**RE: 2618 N MILWAUKEE AVE
PROPOSED EXTERIOR ALTERATIONS –
LOGAN SQUARE BOULEVARDS DISTRICT**

Re: Grace's Furniture Building Redevelopment
2618 N Milwaukee Ave., Chicago, IL 60647
Architectural Review

Review Comments
Logan Square Preservation
August 30, 2019

LOGAN SQUARE HOTEL
K2 **K2 STUDIO**
329 W. 18TH #501, CHICAGO IL. 60616
P: 312.275.5000E: STUDIO@K2ARCH.COM

NEW SITE PLAN
SCALE: 1/16" = 1'-0"

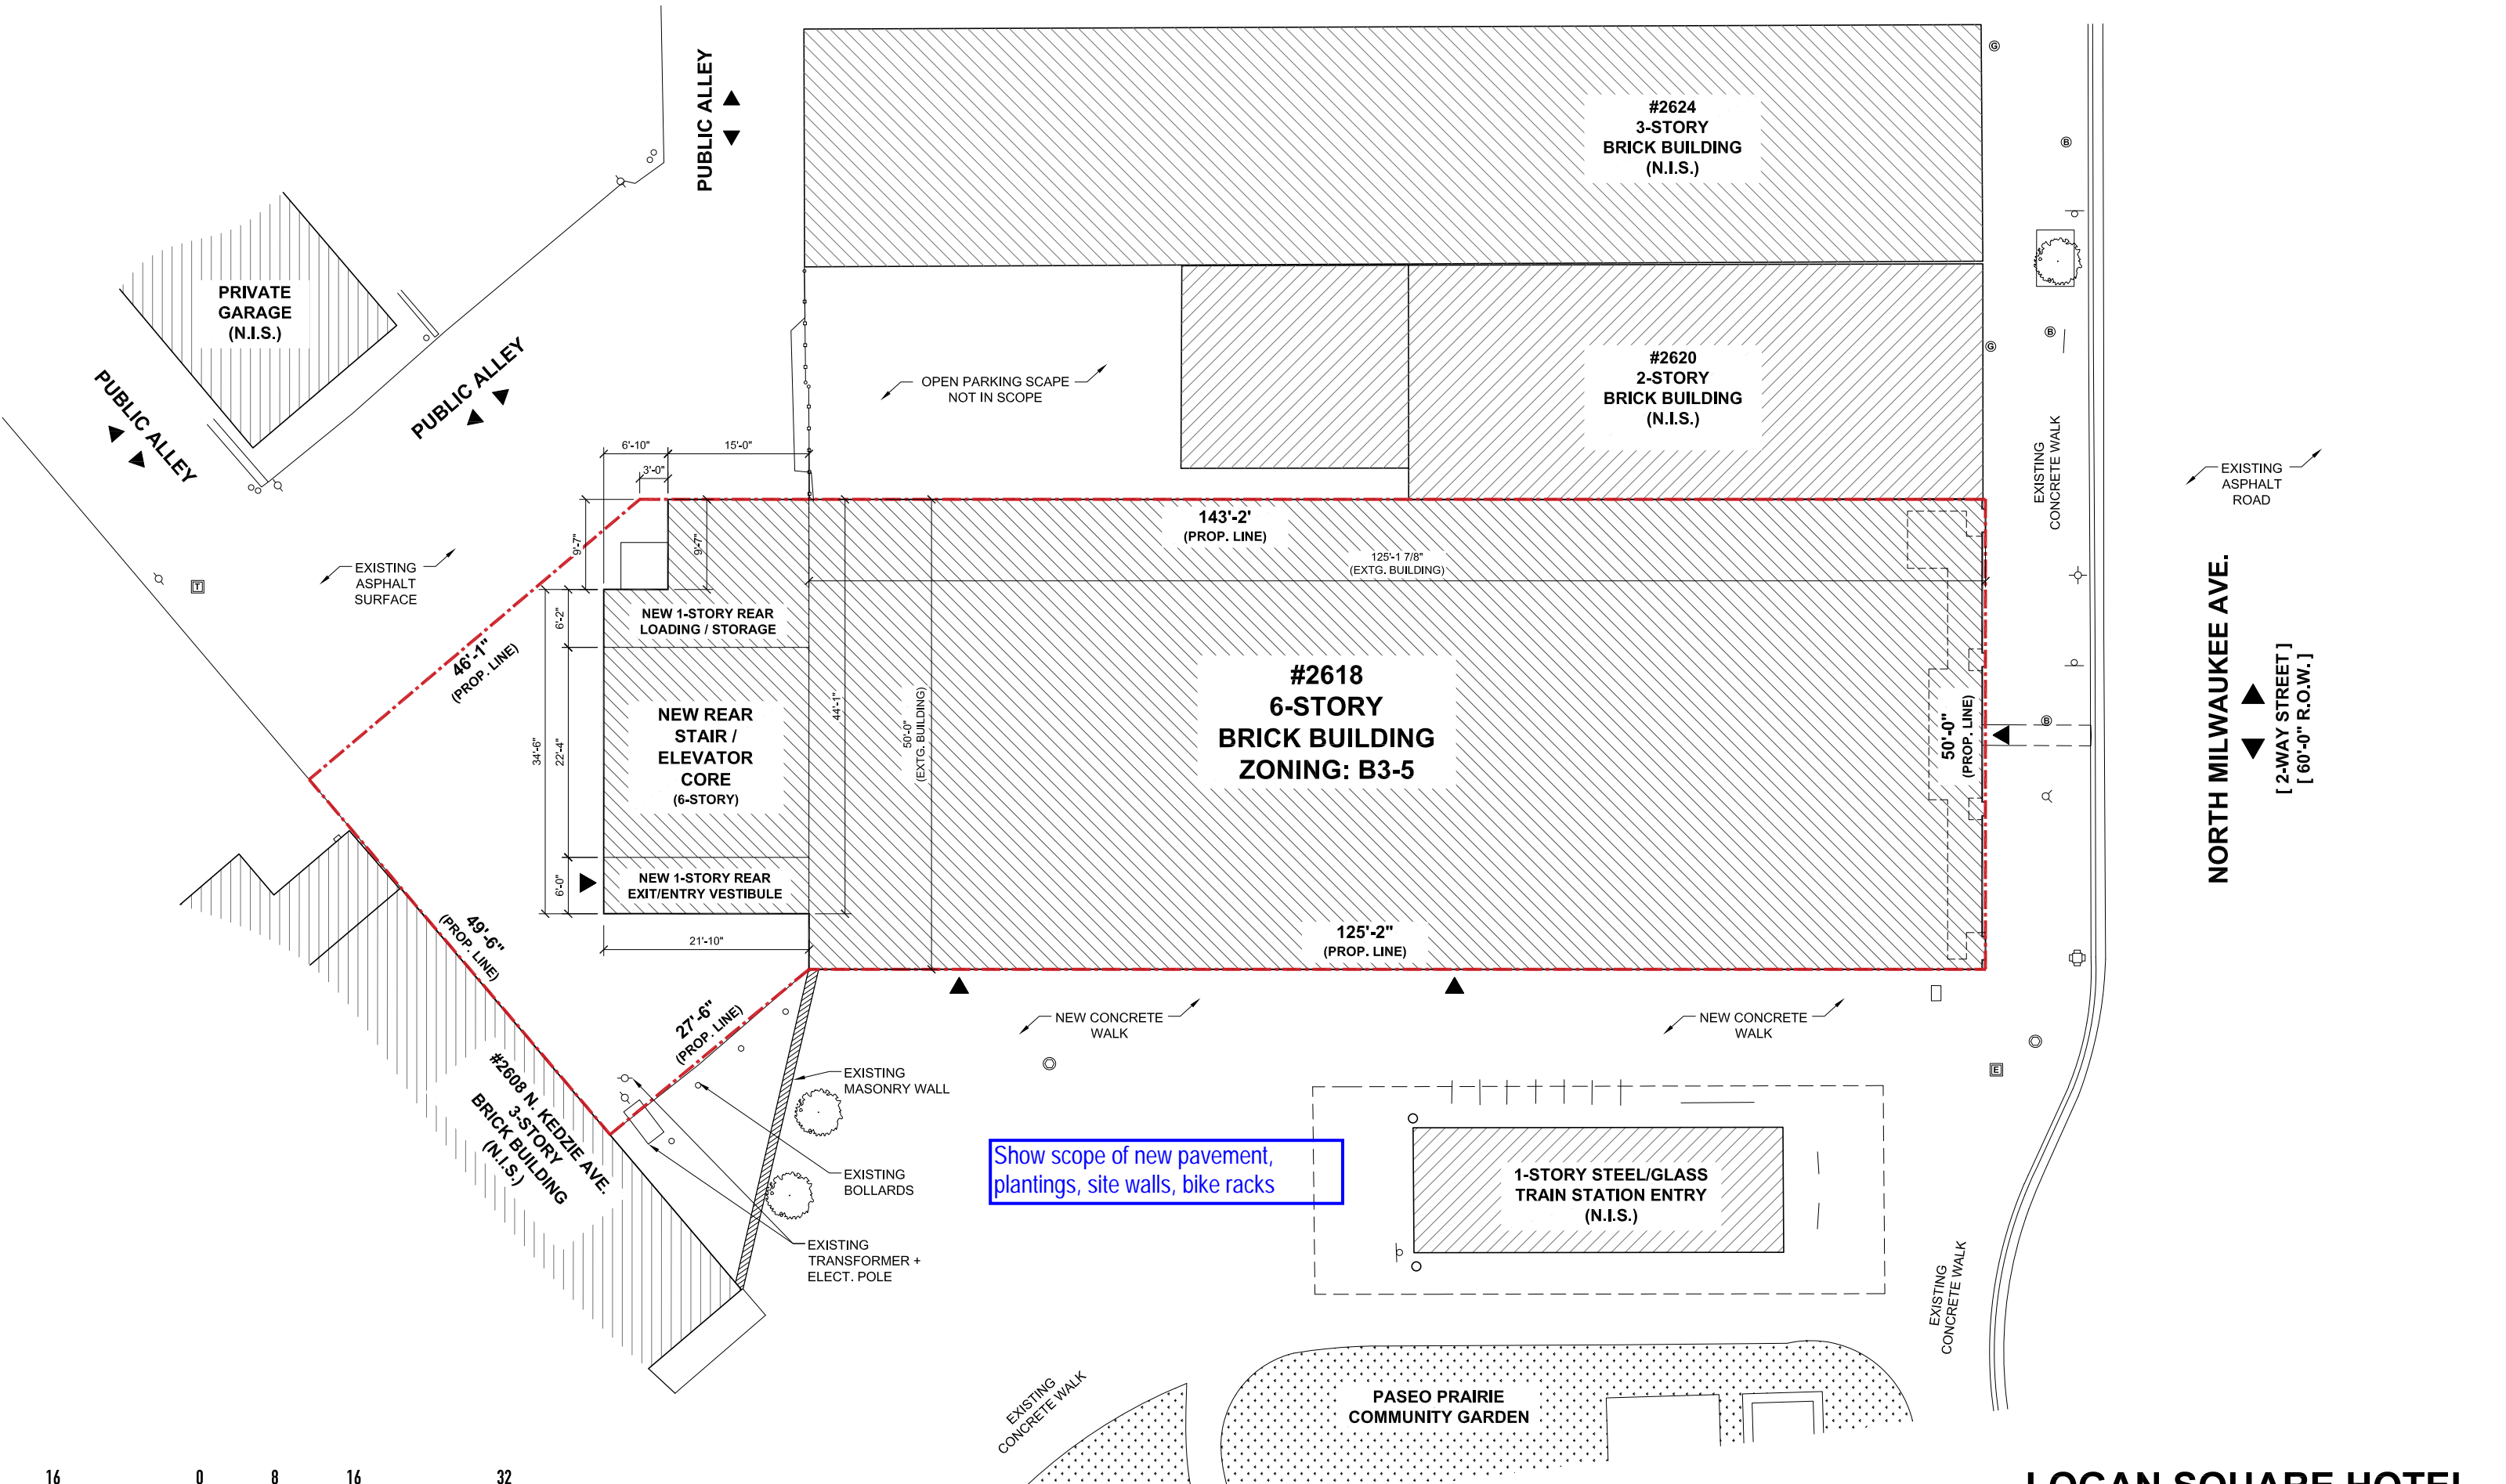
Show scope of new pavement,
plantings, site walls, bike racks

NEW 1st LEVEL PLAN
SCALE: 3/32" = 1'-0"

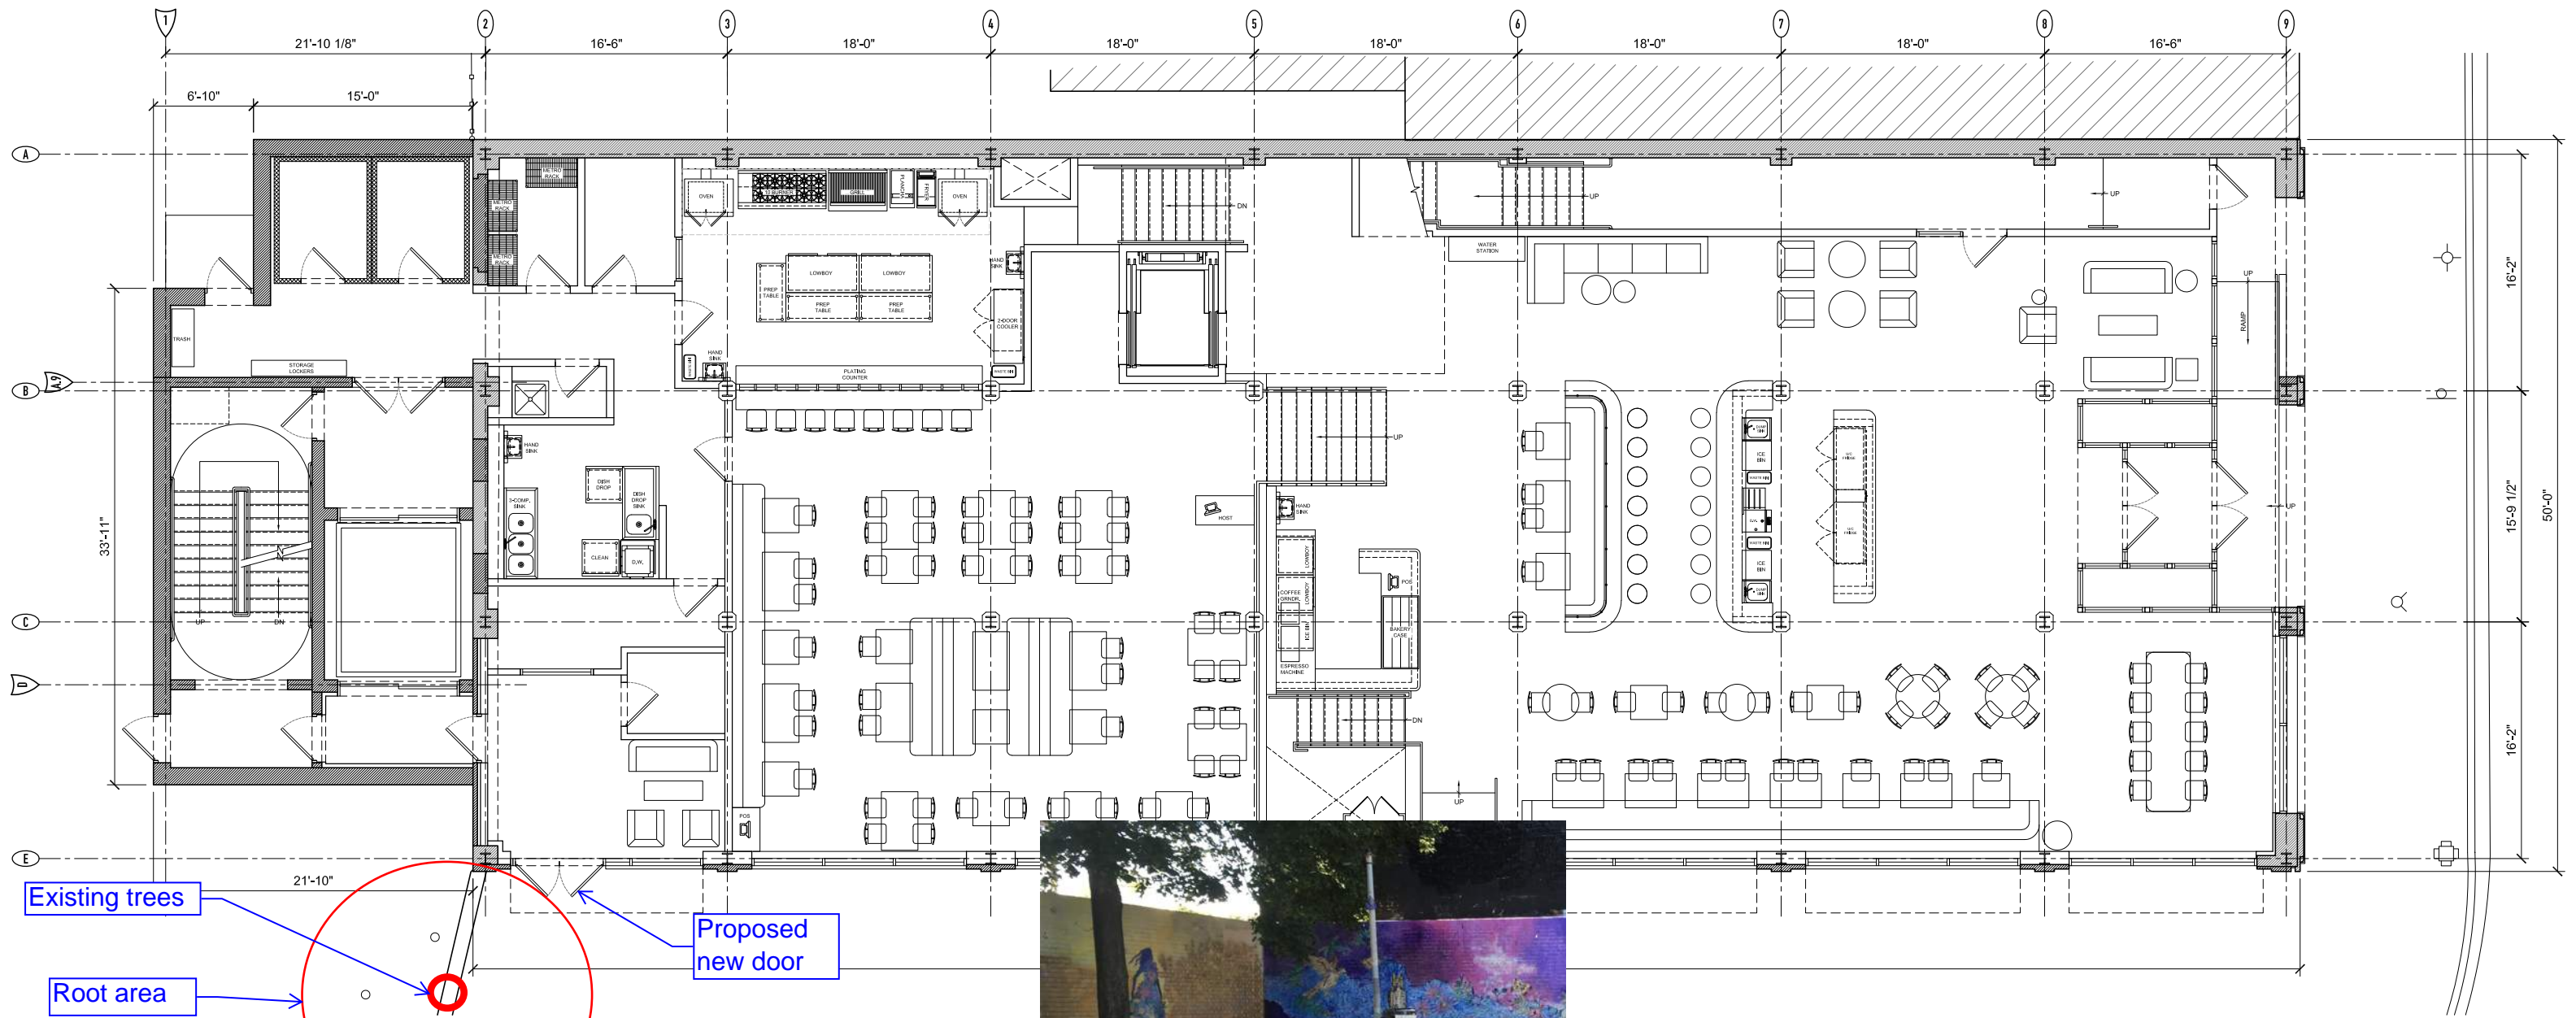
Existing trees

Root area

Proposed new door

7
BRICK VENEER.
MODULAR BRICK TYPE
COLOR: T.B.D.

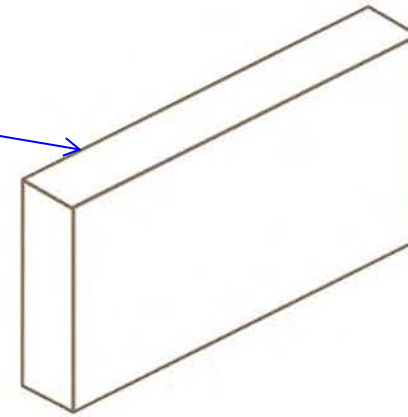
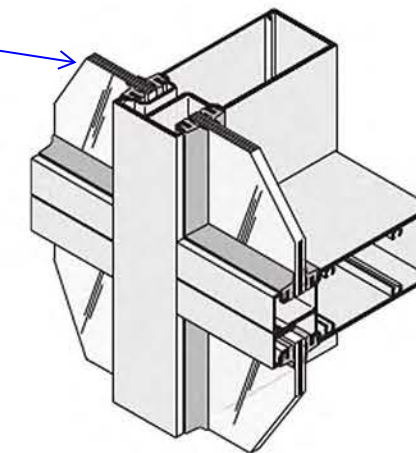
Provide actual material samples and options

Provide actual material samples and options

1a
ANODIZED ALUMINUM
STOREFRONT GLAZING
SYSTEM AT GROUND
FLOOR
COLOR: T.B.D.

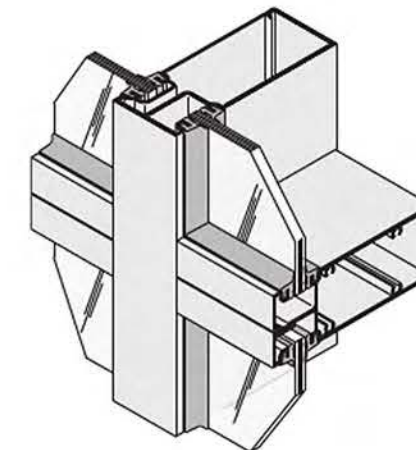
Clear anodized is not acceptable; pls clarify and provide material sample
